To: Brian Stineman, Gregg Mandsager
FROM: Jim Edgmond, City Engineer
Andrew Fangman, City Planner
CC:
DATE: August 29, 2016
RE: Mississippi Drive Corridor Intersection Options

The design of the Mississippi Drive Corridor Project (MDCP) has developed multiple options for the intersections at 2nd Street and Mulberry Avenue and at Carver Corner. These options have been reviewed by City staff and we have the following recommendations.

9.1.2016 Council Meeting

4 Leg Roundabout Alternative:

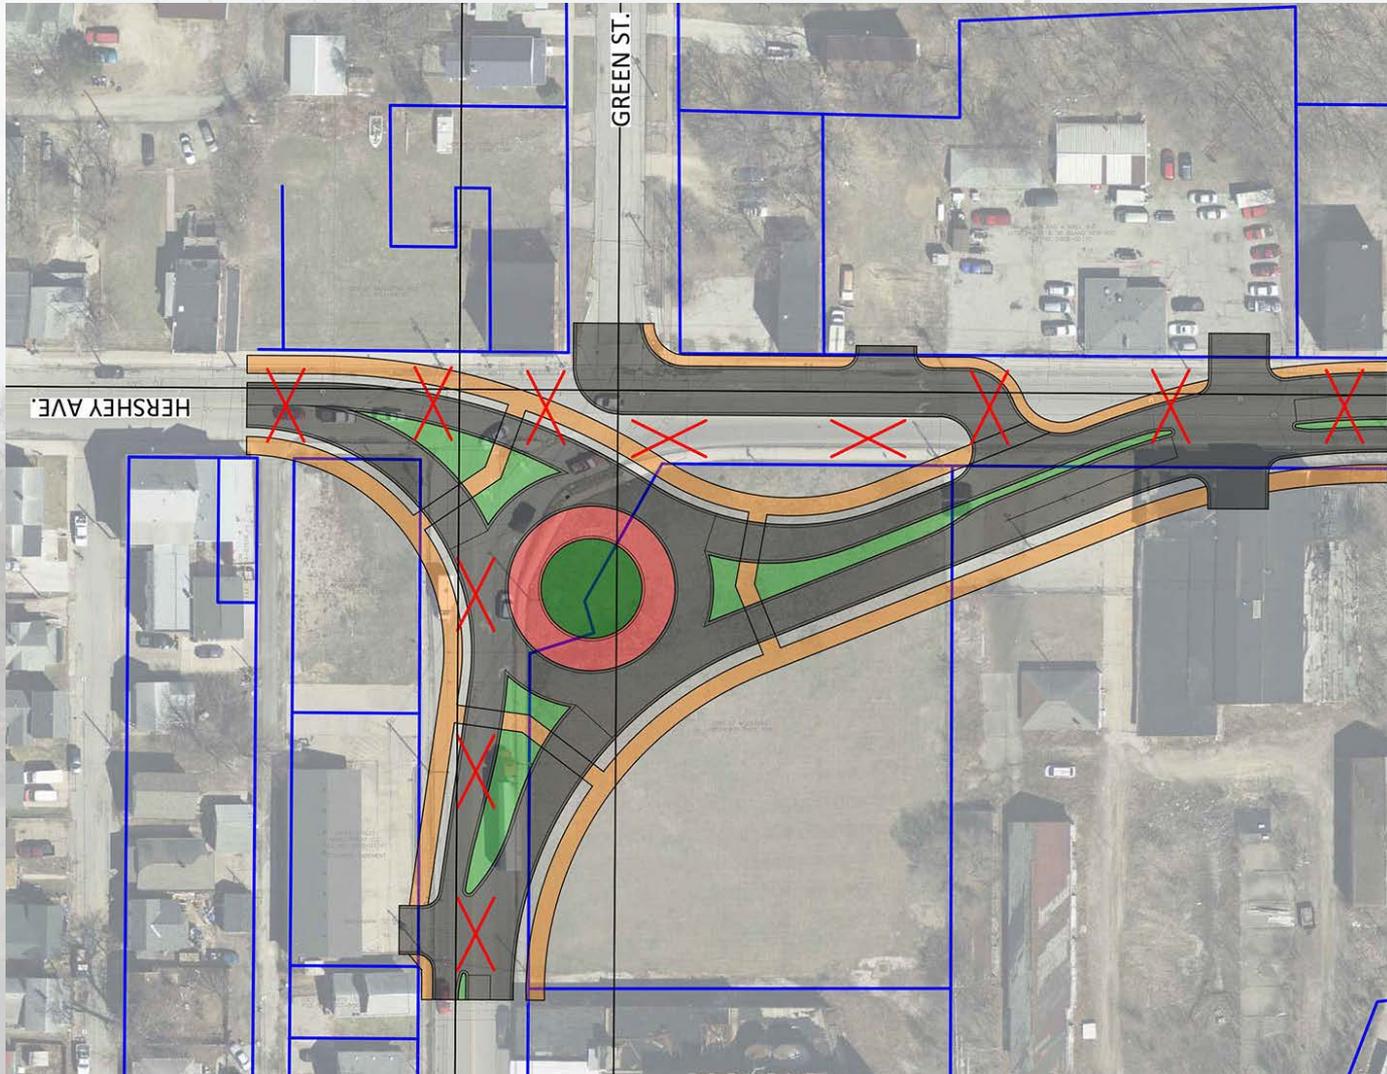
- **Lower costs than signalized (EA) intersection**
- **Free flowing traffic**
- **Gateway to downtown**

- **Different traffic flow than before**
- **Impacts different properties than originally planned – necessitates EA revisions and delayed construction**

MUSCATINE, IOWA
 MISSISSIPPI DRIVE CORRIDOR RECONSTRUCTION
 INTERSECTION - OPTION 1

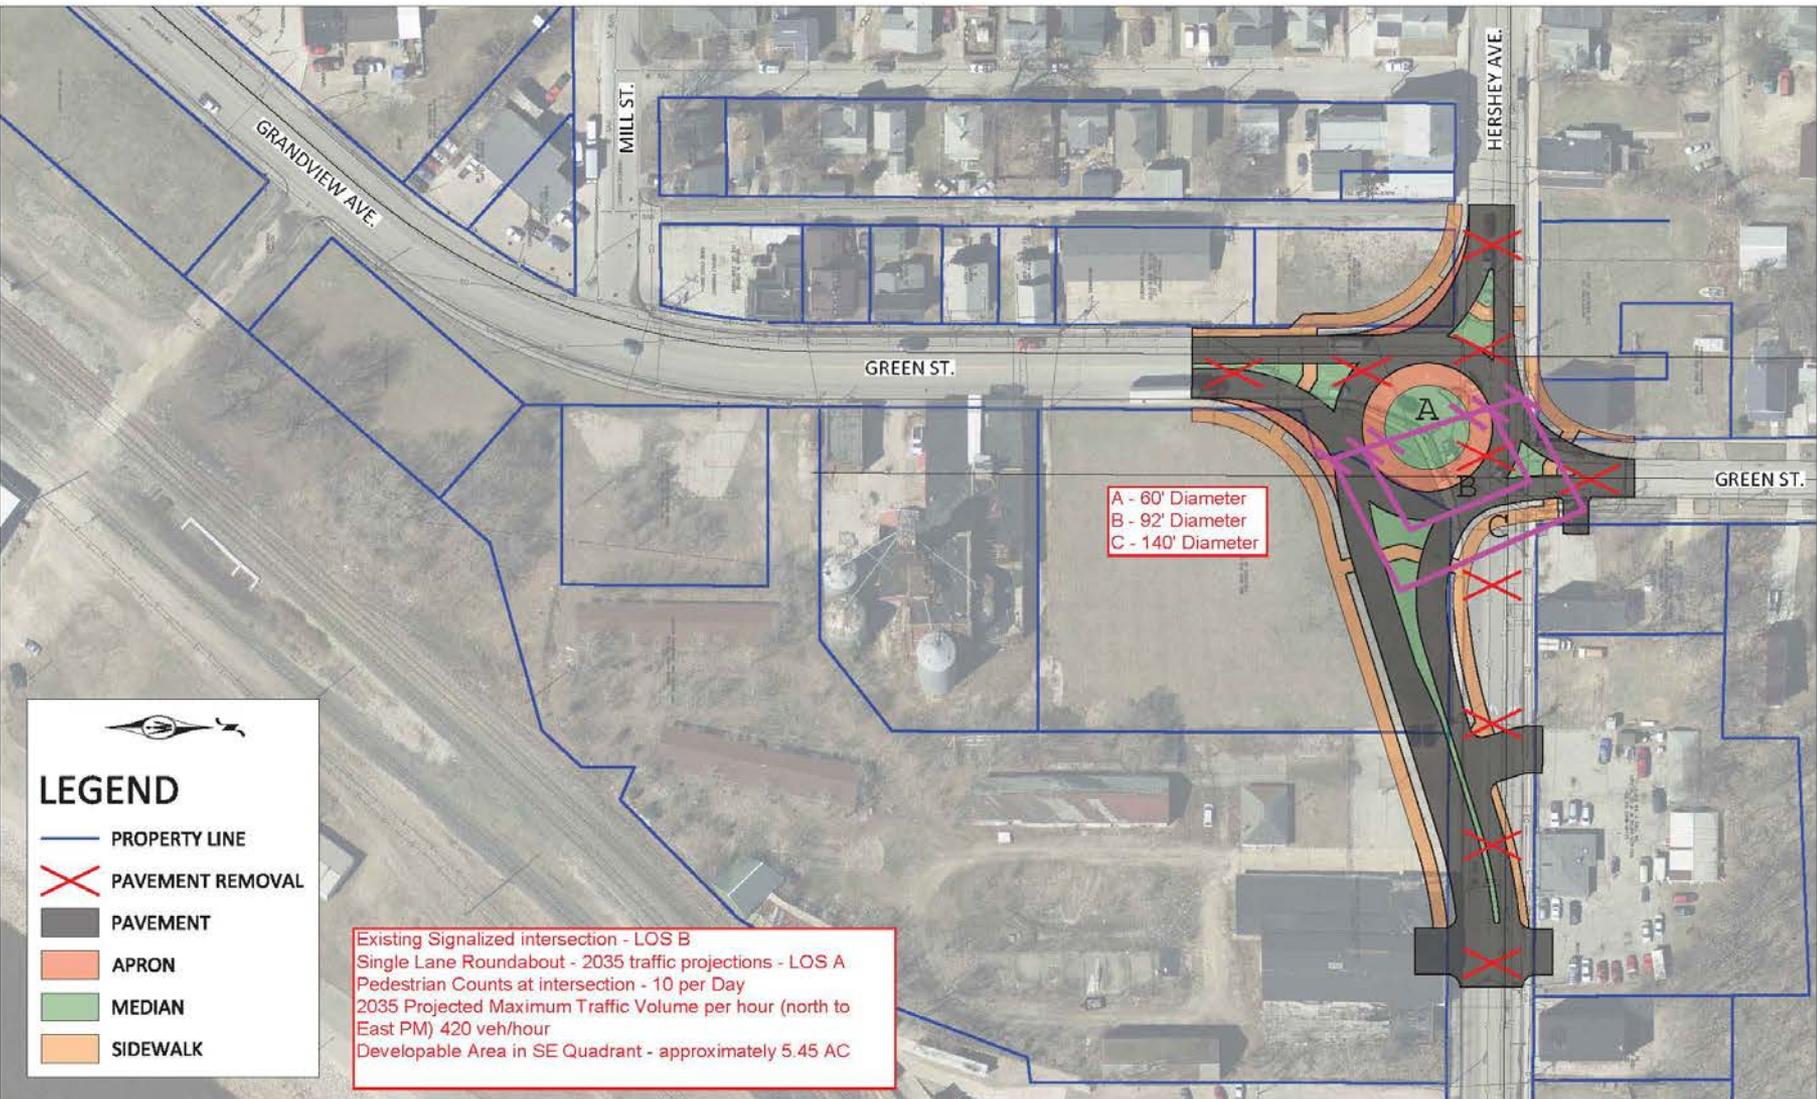
Existing Signalized intersection - LOS B
 Single Lane Roundabout - 2035 traffic projections - LOS A
 Pedestrian Counts at intersection - 10 per Day
 2035 Projected Maximum Traffic Volume per hour (north to East PM) 420 veh/hour
 Developable Area in SE Quadrant - approximately 5.45 AC

Roundabout Comparison | 2nd & Mulberry

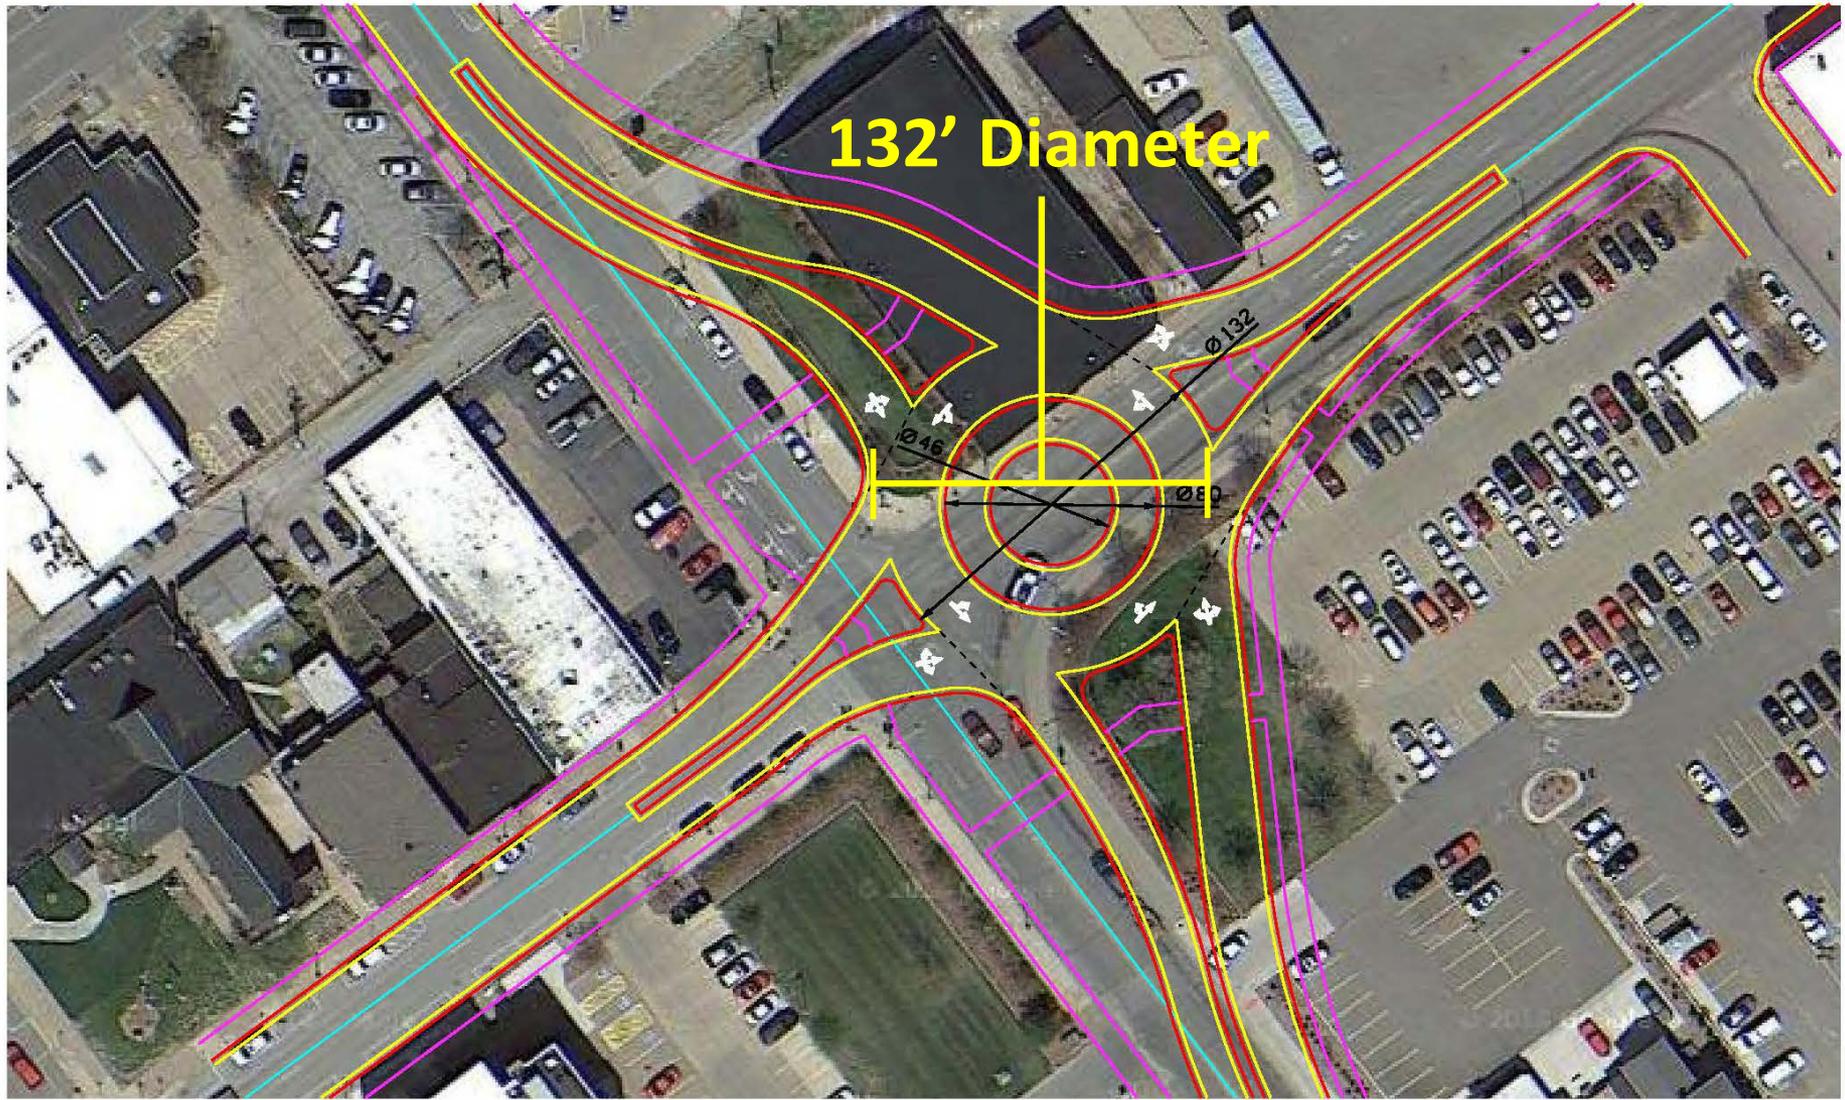
- **Roundabouts at both intersections are a good near and long term solution to both Carver Corner and 2nd and Mulberry**
- **Three legged intersection suits traffic operations, redevelopment options, and fits within EA restrictions**
- **HNI has reviewed 2nd and Mulberry and can utilize both designs, but would prefer the roundabout for their operations**
